Access Compliance Report

Public Rights-of-Way

Intersection ID: 3804	Main Street: MT_ISLE_HARBOR_DR	Cross Street: WRANGELL_LN	Location:	E
ADA ID: 8D206A2C172E	Ramp Type: Perp	Initial Pass/Fail: Fail	Overall Compliance: No	Severity Score: 12.5

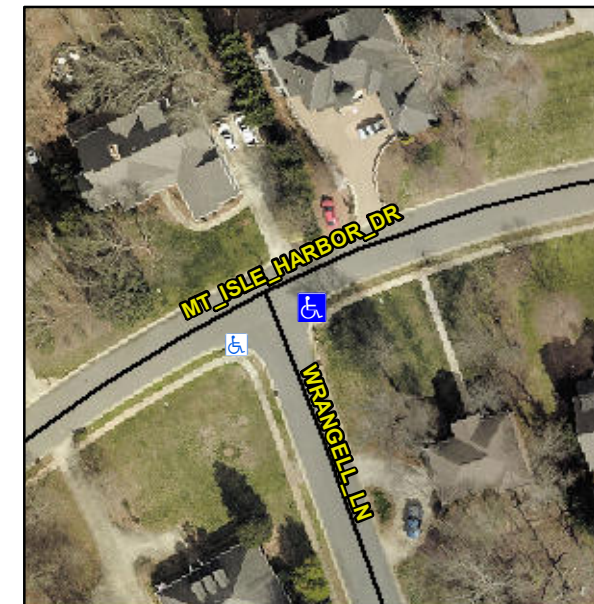
Not Found, R304.5.3

Compliance	Description	Data	Compliance	Description	Data
N/A	Ramp Length (in)	46.0	Yes	Ramp Slope (%)	8.0
Yes	Ramp Width (in)	55.0	No	Ramp XSlope (%)	6.1
N/A	Flare Type LT	N/A	N/A	Flare Type RT	N/A
N/A	Flare Slope LT (%)	N/A	N/A	Flare Slope RT (%)	N/A
N/A	Flare Traversable LT?	N/A	N/A	Flare Traversable RT?	N/A
N/A	Landing Length (in)	N/A	N/A	DWS Provided?	N/A
N/A	Landing Width (in)	N/A	N/A	DWS Contrast?	N/A
N/A	Landing Slope (%)	N/A	N/A	DWS Length (in)	N/A
N/A	Landing X Slope (%)	N/A	N/A	DWS Full Width?	N/A
N/A	Landing Curb? (Y/N)	N/A	N/A	DWS Offset (in)	N/A
N/A	Shared Landing?	N/A			
N/A	Gutter Ponding?	N/A	N/A	Gutter Slope (%)	N/A
N/A	Gutter Lip Ht (in)	N/A	N/A	Gutter X Slope (%)	N/A
N/A	Painted X Walk1?	No	N/A	Painted X Walk2?	N/A
	X Walk 1 Direction	To W		X Walk 2 Direction	N/A
N/A	X Walk 1 Width (in)	N/A	N/A	X Walk 2 Width (in)	N/A
	X Walk 1 Slope (%)	6.1		X Walk 2 Slope (%)	N/A
	X Walk 1 X Slope (%)	0.9		X Walk 2 X Slope (%)	N/A

Remove & Replace Entire Ramp.
